## Technical Service Bulletin – 014

### ***DB AIR air seal head quad ring***

***Old:AAD1163 New:AAD1847***

Rev01 – 4/18/17 - Mike M

Defect examples

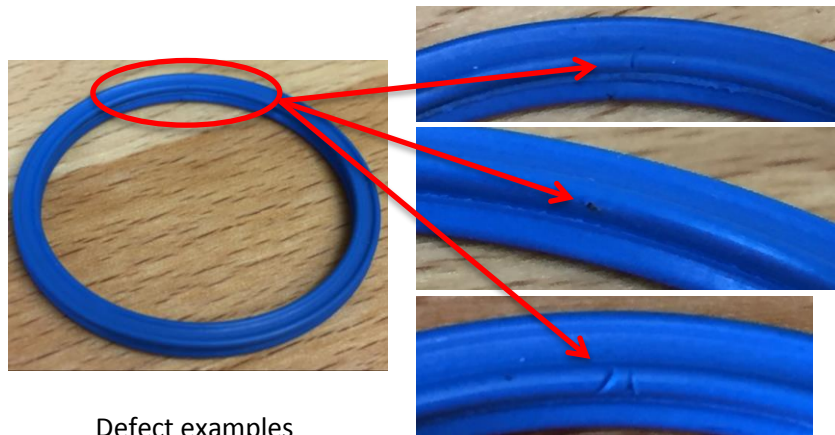
It was discovered that a small batch of new DB AIR; air seal head quad rings (AAD1163) have defects such as cuts and impressions to the inner surface.

All product at Cane Creek has been confirmed to be acceptable for use. Any shocks built after 4/18/17 with Blue Quad rings are confirmed ok. Shocks built before this date are suspect to replacement of the air seal head quad ring. Cane Creek will switch to the black quad rings once all of the remaining blue quad rings have been exhausted from stock.
